Access Compliance Report

Public Rights-of-Way

(Curb Ramps)

Intersection ID: 28912	Main Street: BURKHARD_WY	Cross Street: SPRINGBANK_LN	Location: SW
ADA ID: BFB848BAAC8F	Ramp Type: PerpDiag	Initial Pass/Fail: Fail	Overall Compliance: No
		Severity Score: 12.5

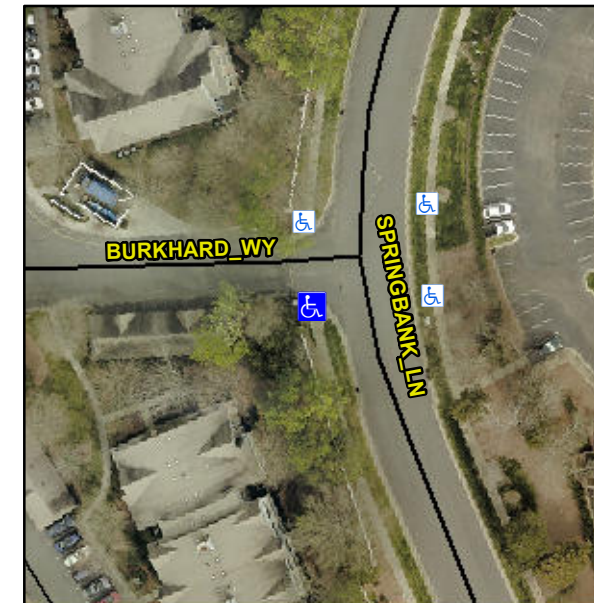
R304.5.3

Compliance	Description	Data	Compliance	Description	Data
N/A	Ramp Length (in)	80.0	Yes	Ramp Slope (%)	8.3
Yes	Ramp Width (in)	58.0	No	Ramp XSlope (%)	6.9
N/A	Flare Type LT	N/A	N/A	Flare Type RT	N/A
N/A	Flare Slope LT (%)	N/A	N/A	Flare Slope RT (%)	N/A
N/A	Flare Traversable LT?	N/A	N/A	Flare Traversable RT?	N/A
N/A	Landing Length (in)	N/A	N/A	DWS Provided?	N/A
N/A	Landing Width (in)	N/A	N/A	DWS Contrast?	N/A
N/A	Landing Slope (%)	N/A	N/A	DWS Length (in)	N/A
N/A	Landing X Slope (%)	N/A	N/A	DWS Full Width?	N/A
N/A	Landing Curb? (Y/N)	N/A	N/A	DWS Offset (in)	N/A
N/A	Shared Landing?	N/A			
N/A	Gutter Ponding?	N/A	N/A	Gutter Slope (%)	N/A
N/A	Gutter Lip Ht (in)	N/A	N/A	Gutter X Slope (%)	N/A
N/A	Painted X Walk1?	No	N/A	Painted X Walk2?	No
	X Walk 1 Direction	To E		X Walk 2 Direction	To N
N/A	X Walk 1 Width (in)	N/A	N/A	X Walk 2 Width (in)	N/A
	X Walk 1 Slope (%)	10.5		X Walk 2 Slope (%)	3.8
	X Walk 1 X Slope (%)	1.6		X Walk 2 X Slope (%)	2.8

Remove & Replace Curb Ramp With Two New Directional Ramps or Equivalent.
